**JOINT ARCHITECTURAL BOARD/PLAN COMMISSION AGENDA**  
**MONDAY, JANUARY 19, 2015**  
**7:00 PM**  
**BOARD ROOM, MUNICIPAL BUILDING, 210 COTTONWOOD AVE.**

**VILLAGE OF HARTLAND  
JOINT ARCHITECTURAL BOARD/PLAN COMMISSION MINUTES  
MONDAY, DECEMBER 15, 2014  
7:00 PM  
BOARD ROOM, MUNICIPAL BUILDING, 210 COTTONWOOD AVE.**

**TO:** Plan Commission  
**FROM:** David E. Cox, Village Administrator   
**DATE:** January 16, 2015  
**SUBJECT:** Riverwalk PUD

Hartland, Wisconsin  
SHEET TITLE  
Site Lighting Plan

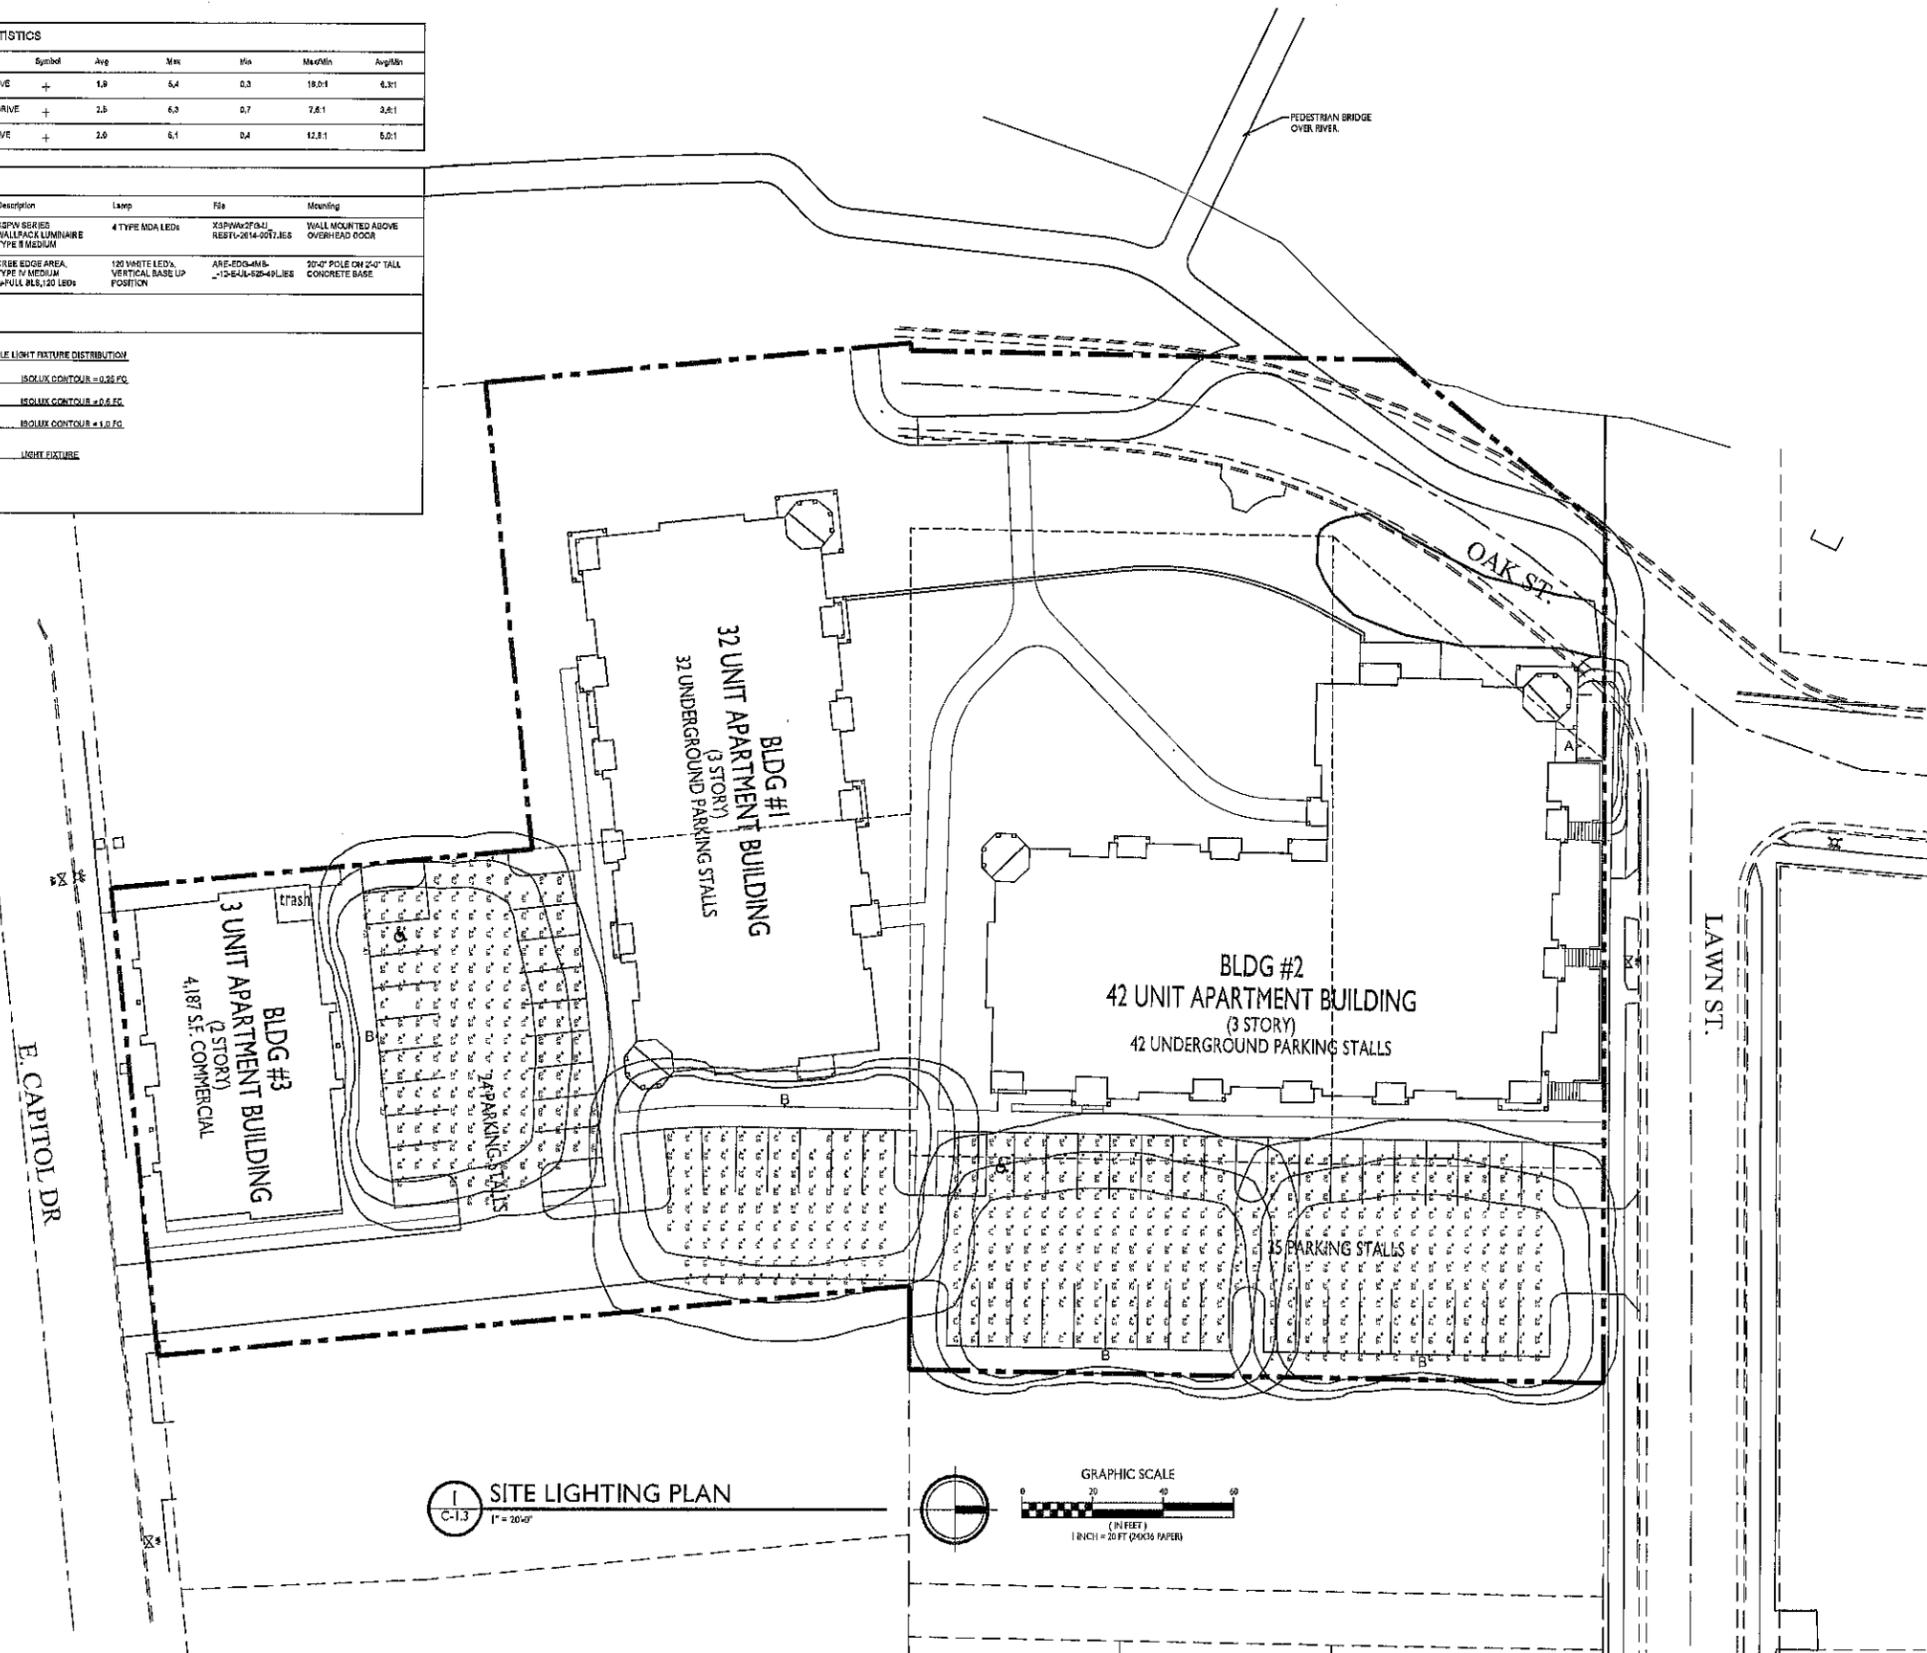
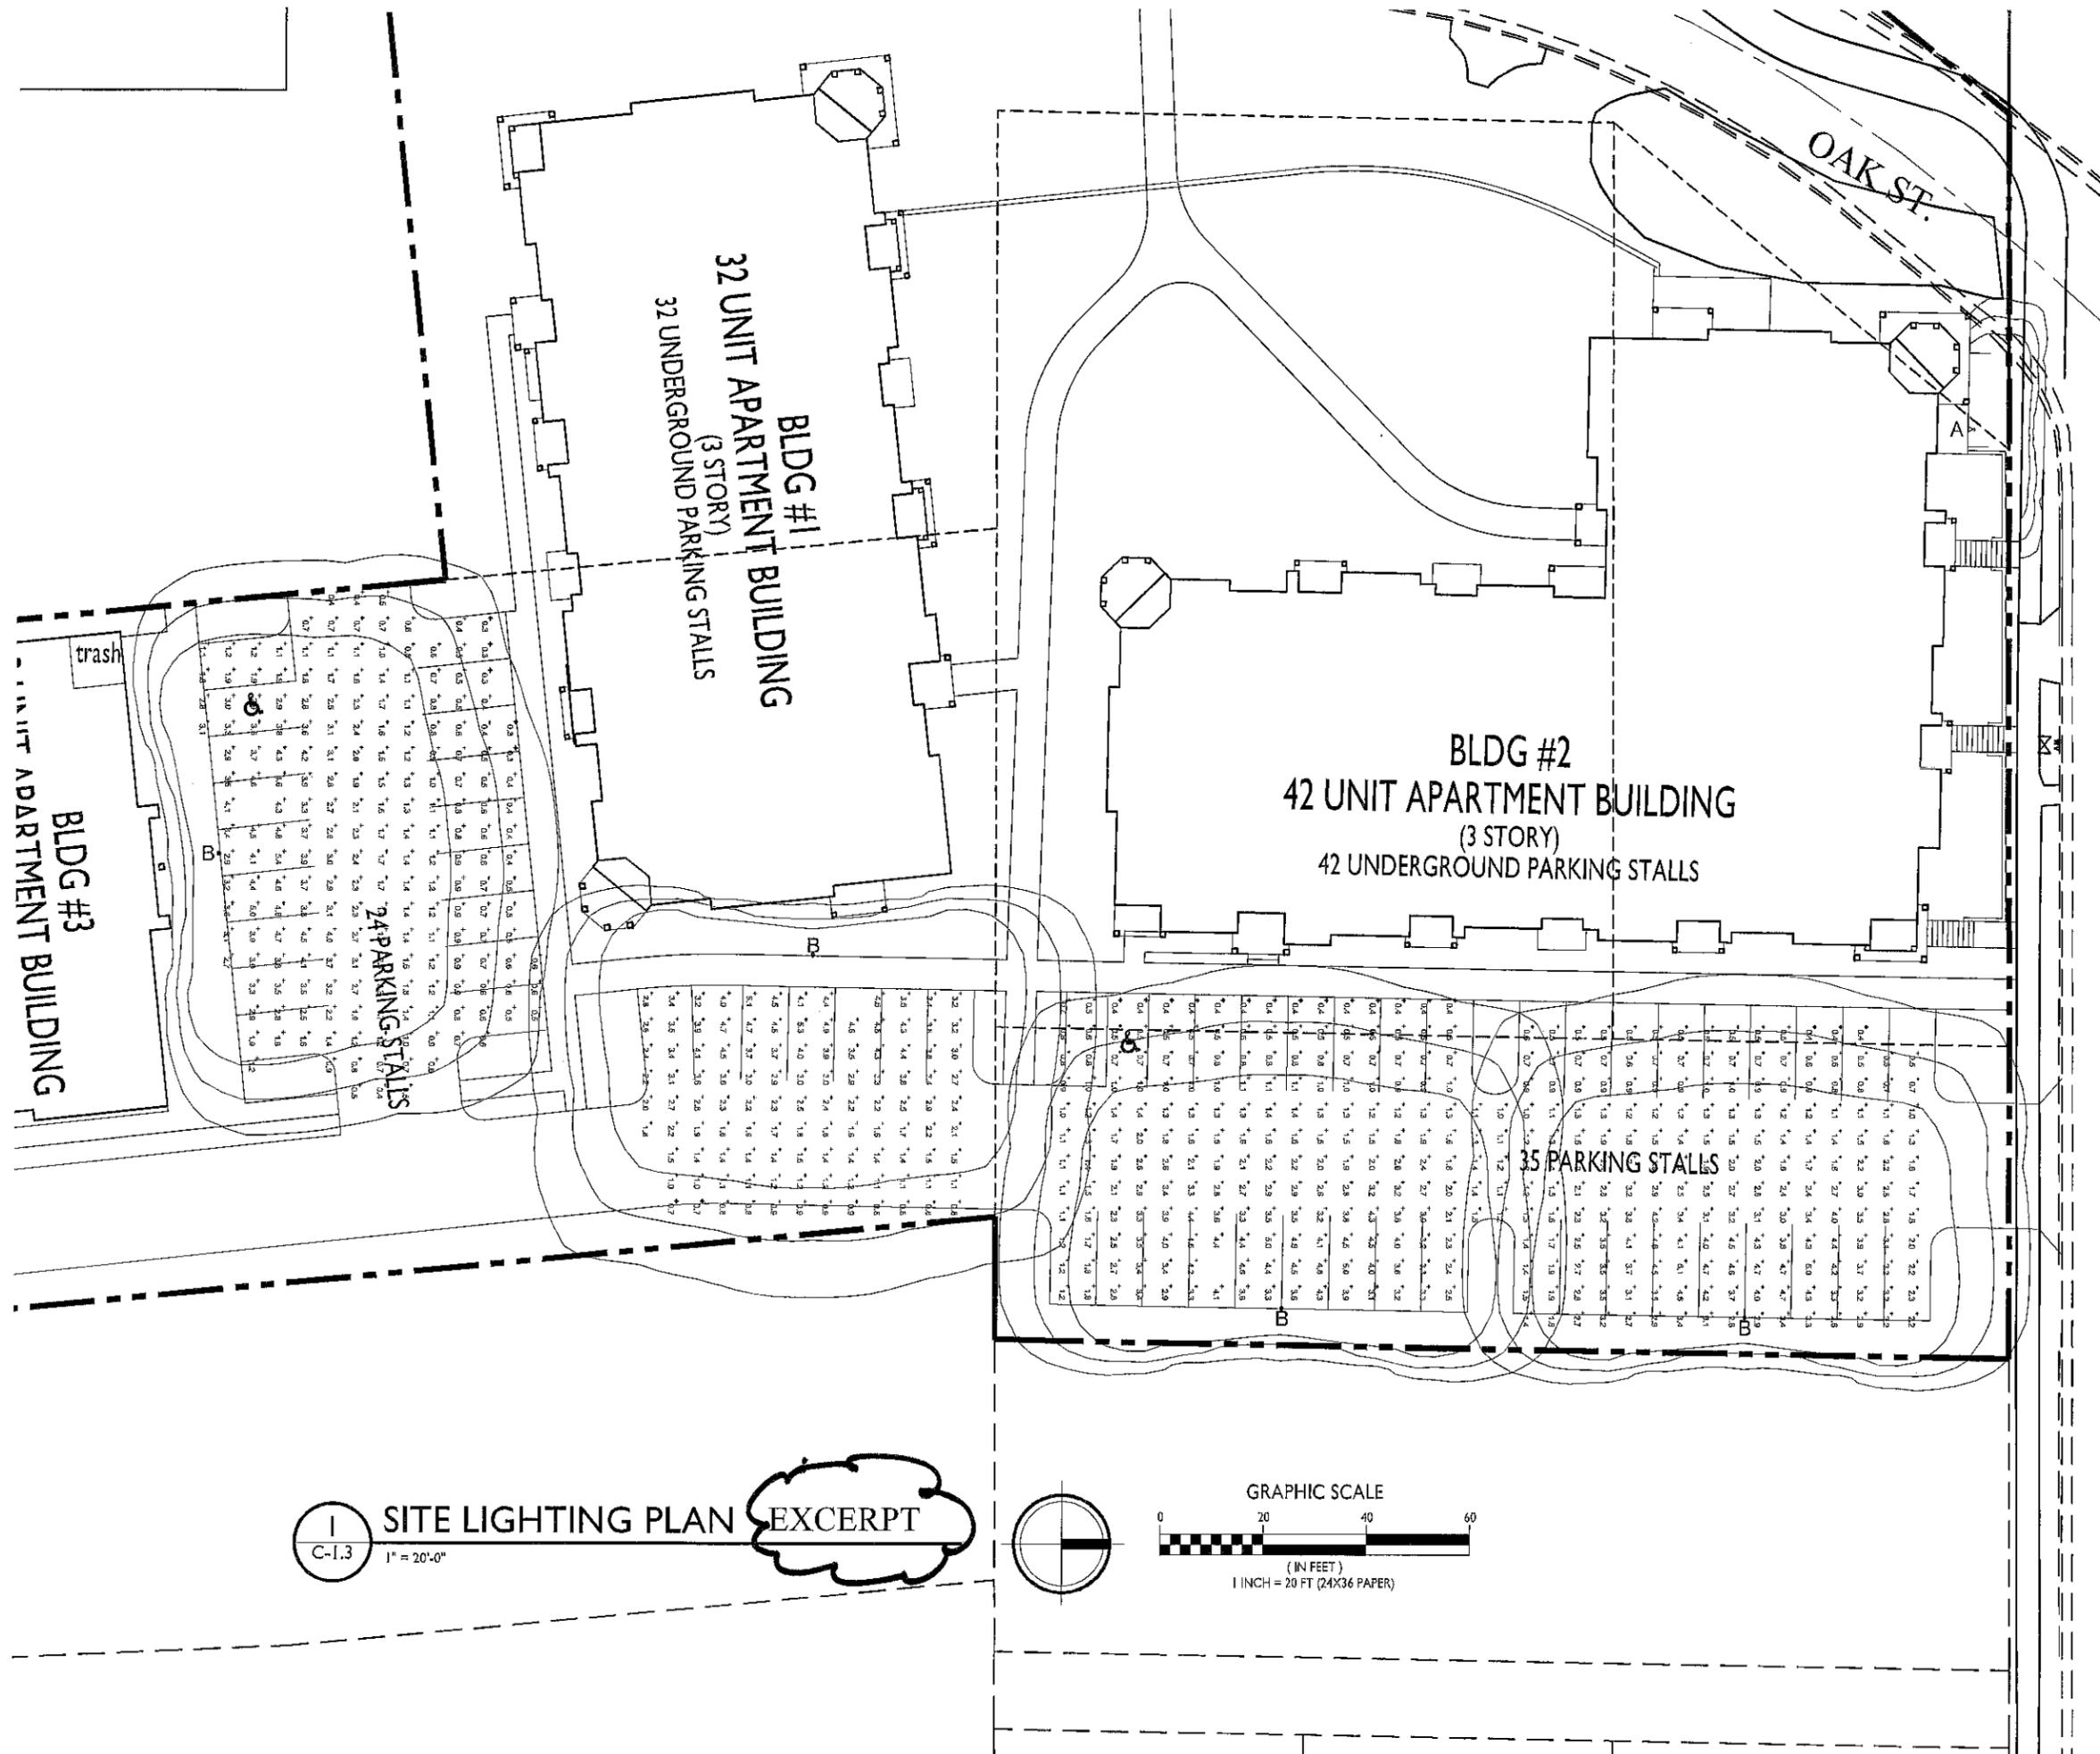
- A finalized lighting plan needs to be developed.
- Show a definitive plan for the fence along the east side as well as overall landscaping.
- Revised Landscape Plan should address the saving of quality mature trees and clearly identify the mature trees to be removed.
